Re: Docket No. 461 - CSC 461 Greenwich Substation and Line Project

Response to OCC-04 Interrogatories dated 11/17/2015

**CL&P dba Eversource Energy**  
**Docket No. 461**

**Data Request OCC-04**  
**Dated: 11/17/2015**  
**Q-OCC-041**  
**Page 1 of 1**

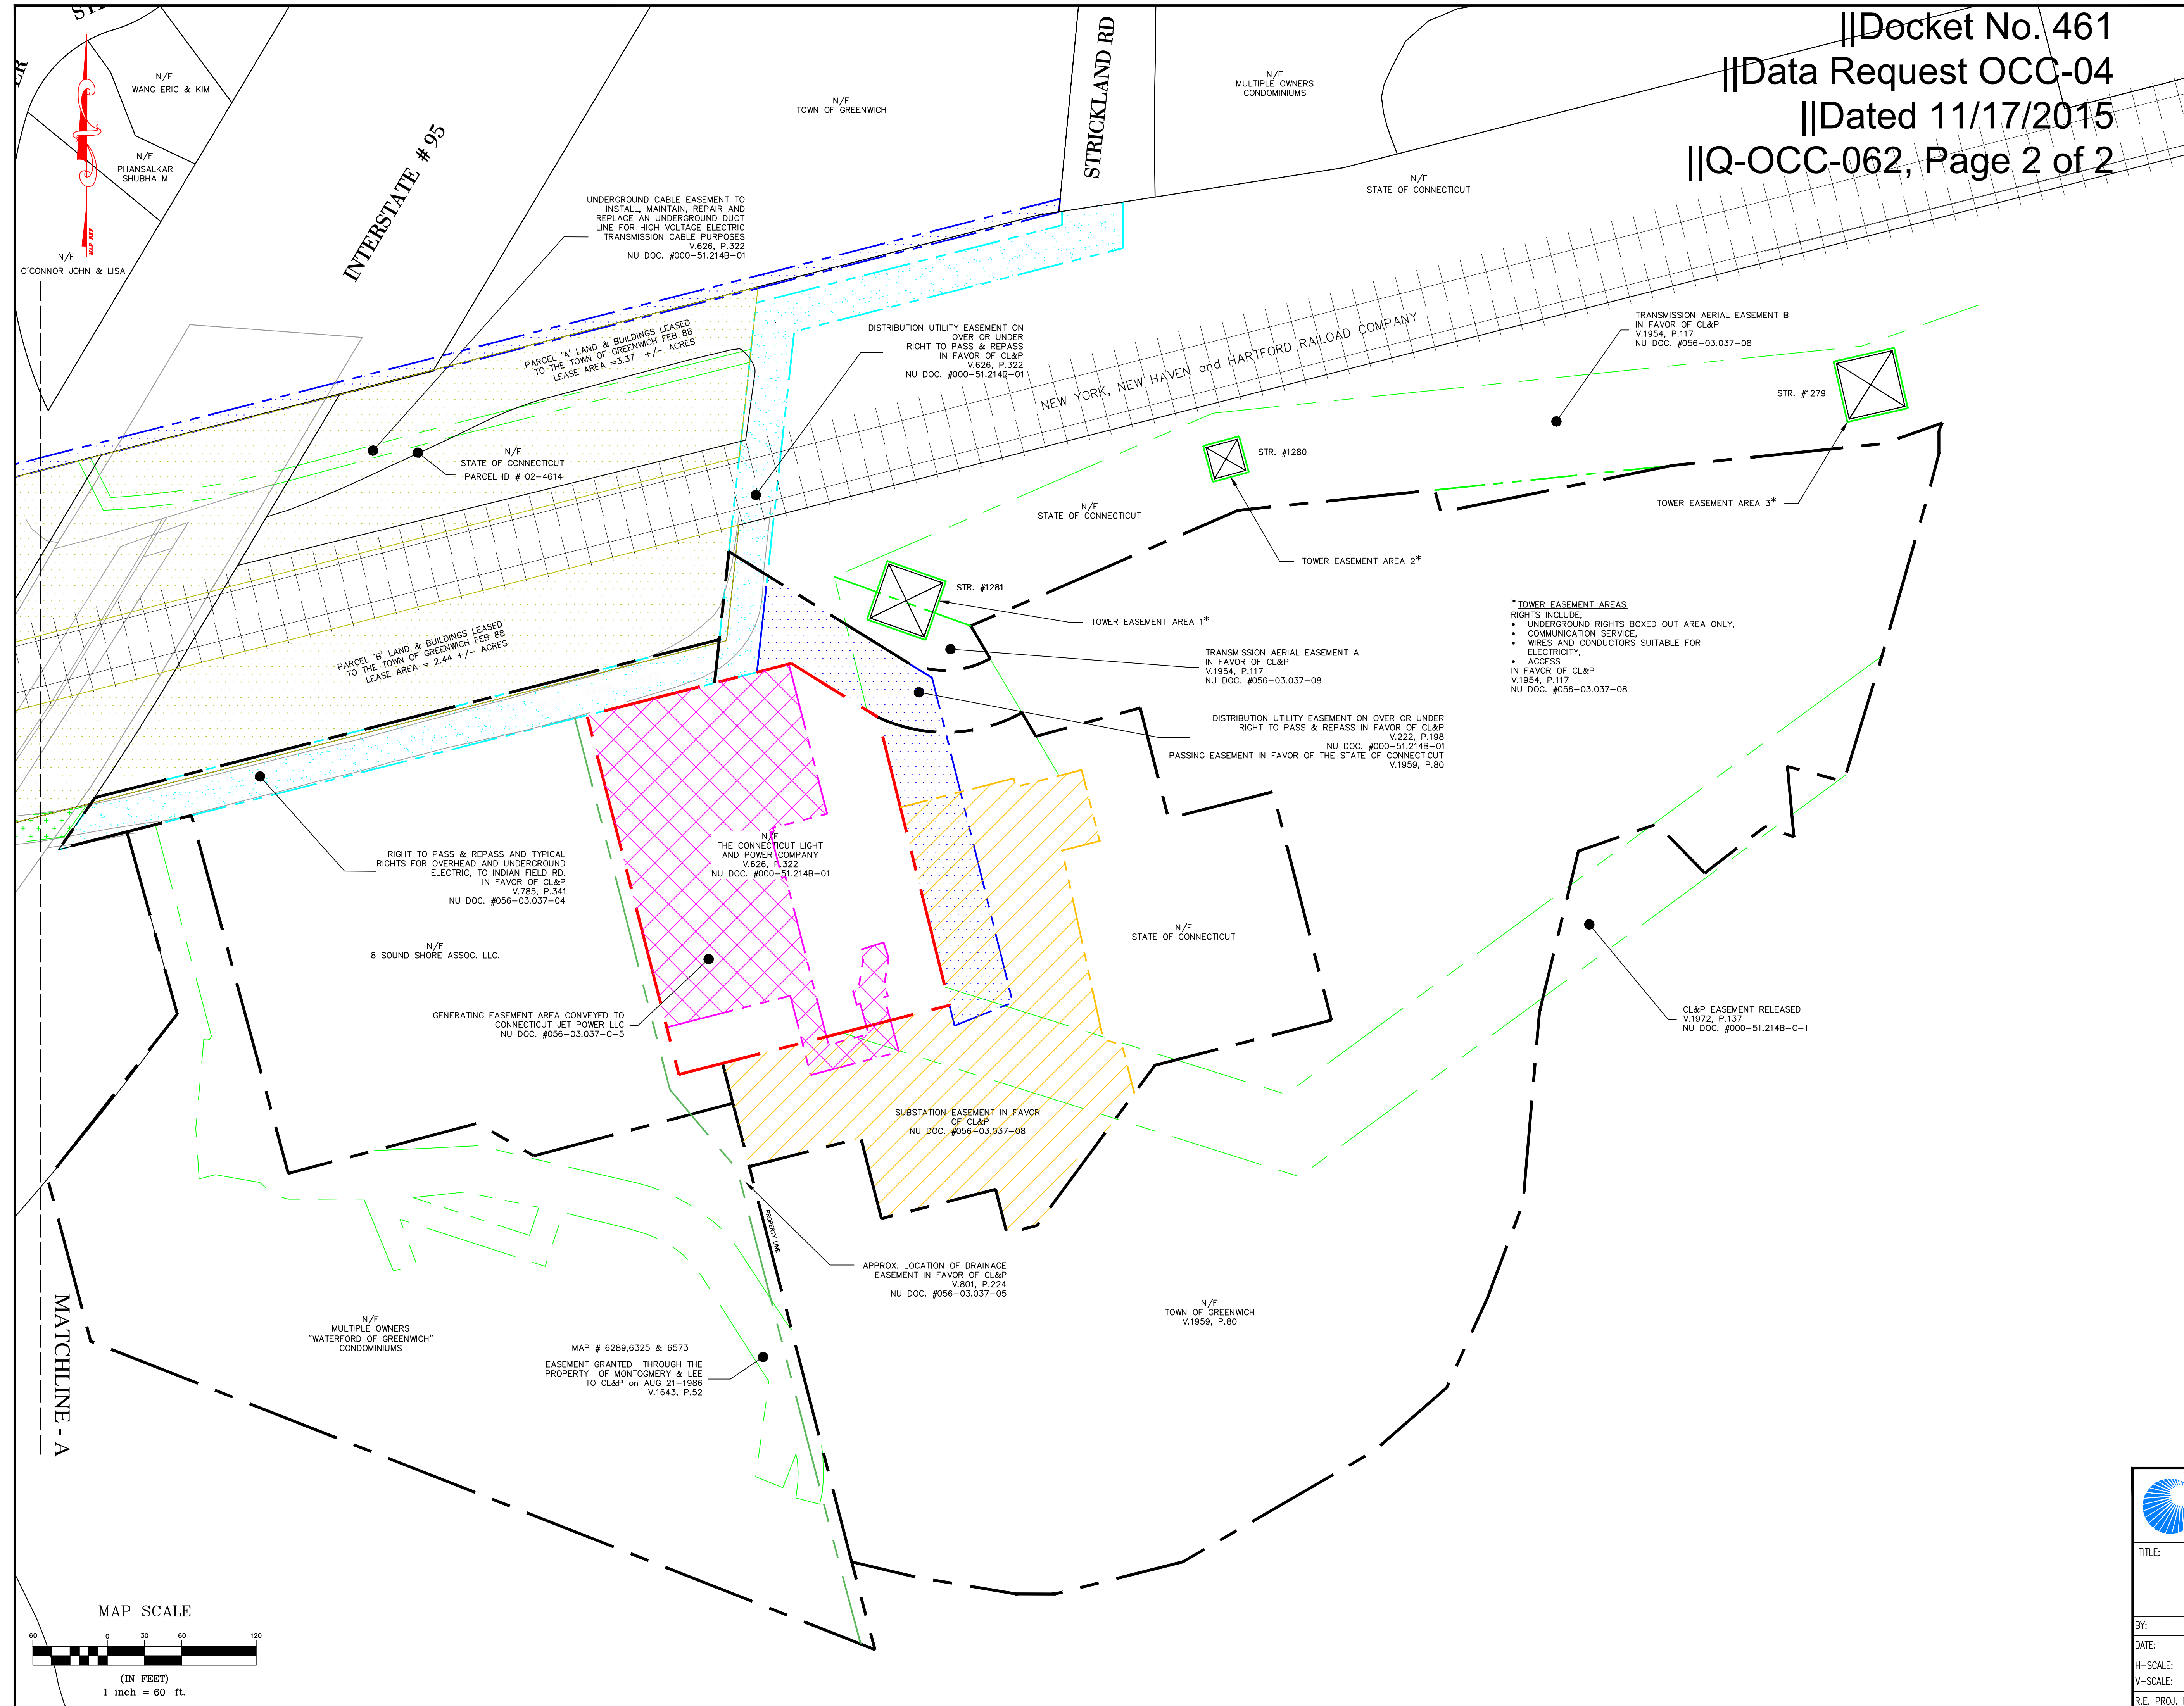
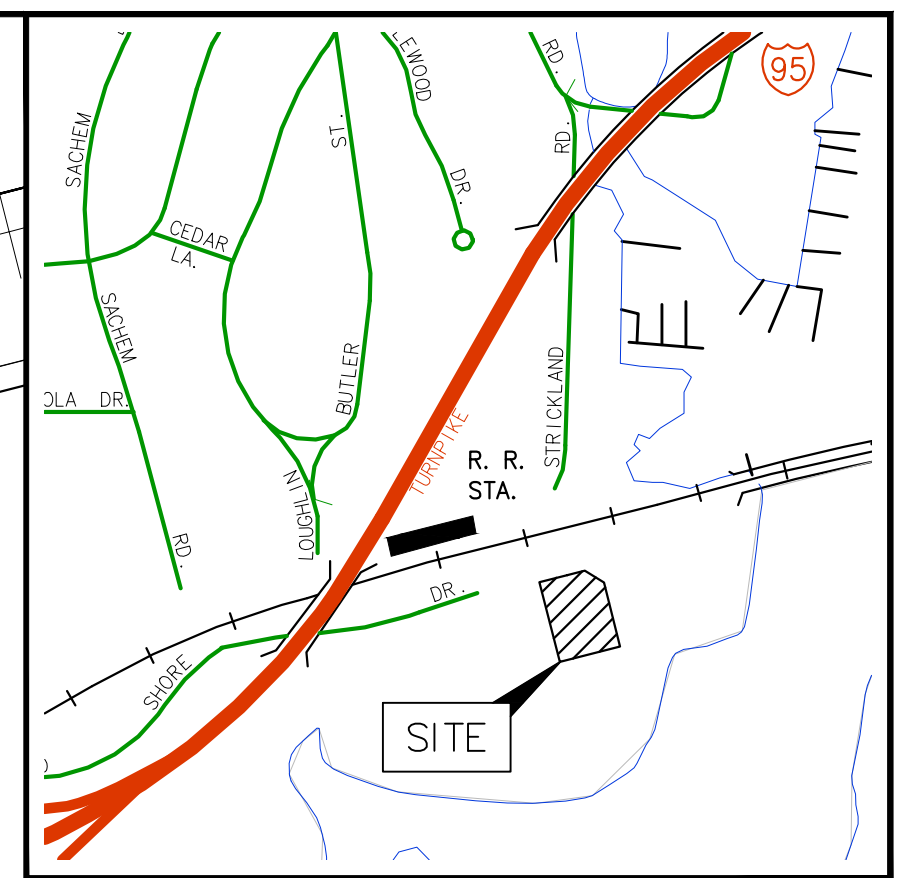
Provide a detailed blueprint, including all dimensions of Cos Cob substation building and equipment, that identifies all used and unused space.

See the plot plan for a detailed blueprint of the Cos Cob Substation facility in Attachment 1, page 1. A small unused area within the Eversource-owned parcel is noted on the drawing. Note that there is also a portion of CDOT-owned property that extends on the south side of the substation as shown in Attachment 1, page 2.
